## Product Change Notification (PCN)

**Products affected:** series 579-1  
**Description of part:** housing for crimp terminal, pitch 3.96mm

old version 579-1	new version 579-2

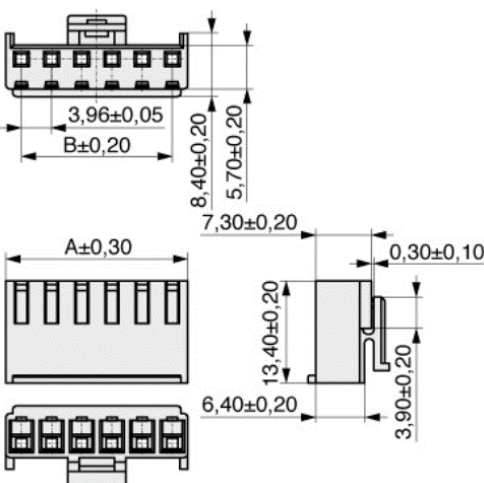
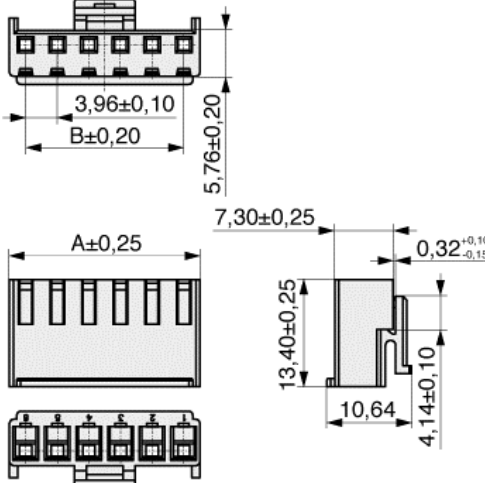
**Description of change:** Change of dimensions.  
**Reason for change:** Revision of the plug-in system.

**Please note:** Series 579-1 will be replaced by series 579-2. The old version 579-1 is not compatible with the new version 579-2 and its related products.

Temperature Range: -25°C to 105°C	Temperature Range: -25°C to 85°C																																																																																							
<table border="1"> <thead> <tr> <th>Pincount</th> <th>A</th> <th>B</th> </tr> </thead> <tbody> <tr><td>2</td><td>8,10</td><td>3,96</td></tr> <tr><td>3</td><td>12,06</td><td>7,92</td></tr> <tr><td>4</td><td>16,02</td><td>11,88</td></tr> <tr><td>5</td><td>19,98</td><td>15,84</td></tr> <tr><td>6</td><td>23,94</td><td>19,80</td></tr> <tr><td>7</td><td>27,90</td><td>23,76</td></tr> <tr><td>8</td><td>31,86</td><td>27,72</td></tr> <tr><td>9</td><td>35,82</td><td>31,68</td></tr> <tr><td>10</td><td>39,78</td><td>35,64</td></tr> <tr><td>11</td><td>43,74</td><td>39,60</td></tr> <tr><td>12</td><td>47,70</td><td>43,56</td></tr> <tr><td>13</td><td>51,66</td><td>47,52</td></tr> <tr><td>14</td><td>55,62</td><td>51,48</td></tr> </tbody> </table>	Pincount	A	B	2	8,10	3,96	3	12,06	7,92	4	16,02	11,88	5	19,98	15,84	6	23,94	19,80	7	27,90	23,76	8	31,86	27,72	9	35,82	31,68	10	39,78	35,64	11	43,74	39,60	12	47,70	43,56	13	51,66	47,52	14	55,62	51,48	<table border="1"> <thead> <tr> <th>Pincount</th> <th>A</th> <th>B</th> </tr> </thead> <tbody> <tr><td>2</td><td>8,02</td><td>3,96</td></tr> <tr><td>3</td><td>11,98</td><td>7,92</td></tr> <tr><td>4</td><td>15,94</td><td>11,88</td></tr> <tr><td>5</td><td>19,90</td><td>15,84</td></tr> <tr><td>6</td><td>23,86</td><td>19,80</td></tr> <tr><td>7</td><td>27,82</td><td>23,76</td></tr> <tr><td>8</td><td>31,78</td><td>27,72</td></tr> <tr><td>9</td><td>35,74</td><td>31,68</td></tr> <tr><td>10</td><td>39,70</td><td>35,64</td></tr> <tr><td>11</td><td>43,66</td><td>39,60</td></tr> <tr><td>12</td><td>47,62</td><td>43,56</td></tr> <tr><td>13</td><td>51,58</td><td>47,52</td></tr> <tr><td>14</td><td>55,54</td><td>51,48</td></tr> <tr><td>15</td><td>59,50</td><td>55,44</td></tr> </tbody> </table>	Pincount	A	B	2	8,02	3,96	3	11,98	7,92	4	15,94	11,88	5	19,90	15,84	6	23,86	19,80	7	27,82	23,76	8	31,78	27,72	9	35,74	31,68	10	39,70	35,64	11	43,66	39,60	12	47,62	43,56	13	51,58	47,52	14	55,54	51,48	15	59,50	55,44
